Advisory Committee Report

Rosemaur Gallery Proposal Harkaway

Draft Amendment Casey C273case

12 May 2021

Figure 2: Site layout

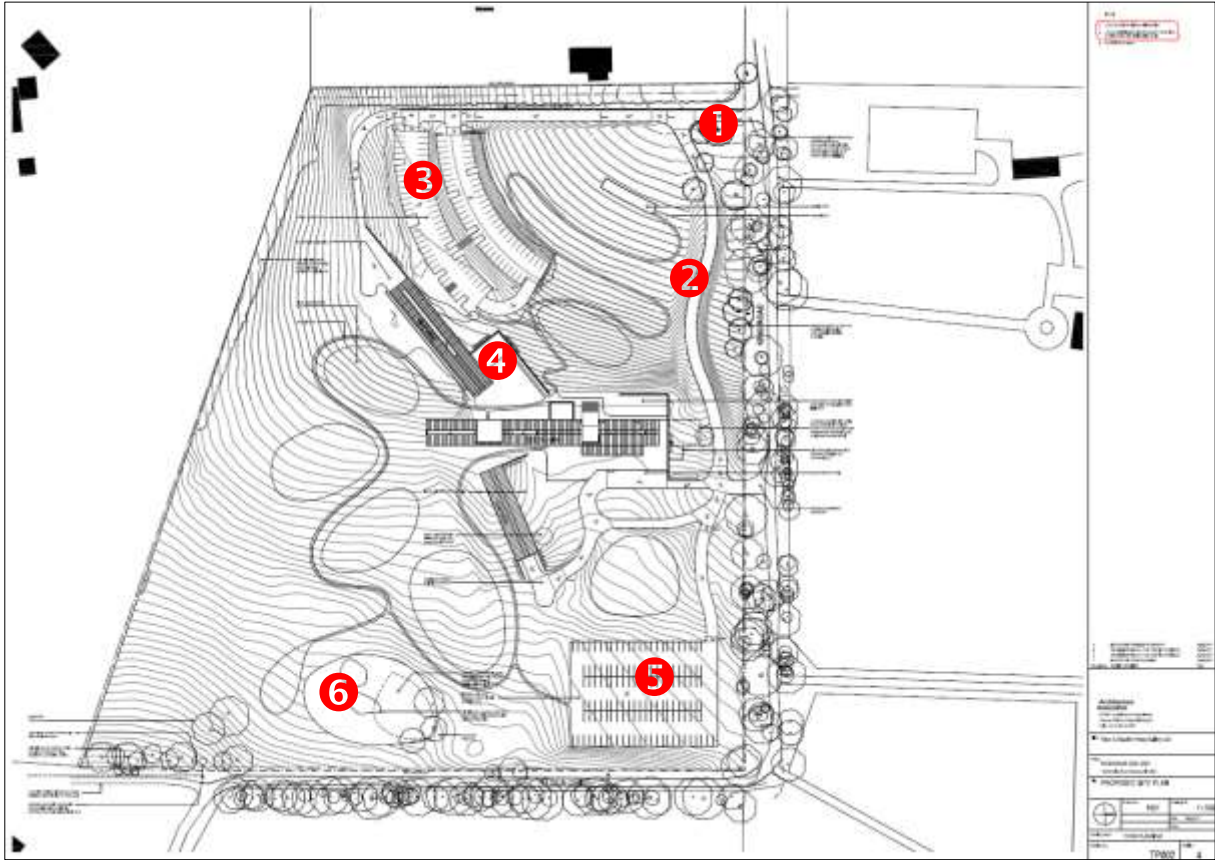
Examining the proposed usage patterns and car parking supply it appears to the Advisory Committee that the overflow car park may be used more often than expected by the planners unless maximum patron numbers are further limited. The overflow car park is not appropriate for regular use and patronage limits should be modified to control this.

The modified site layout includes a re-designed sealed car park, an internal connecting road to the overflow car park and eastern loading docks and coach zone, details on grades and retaining walls, and restriction of the eastern access to King Road for vehicle use only.
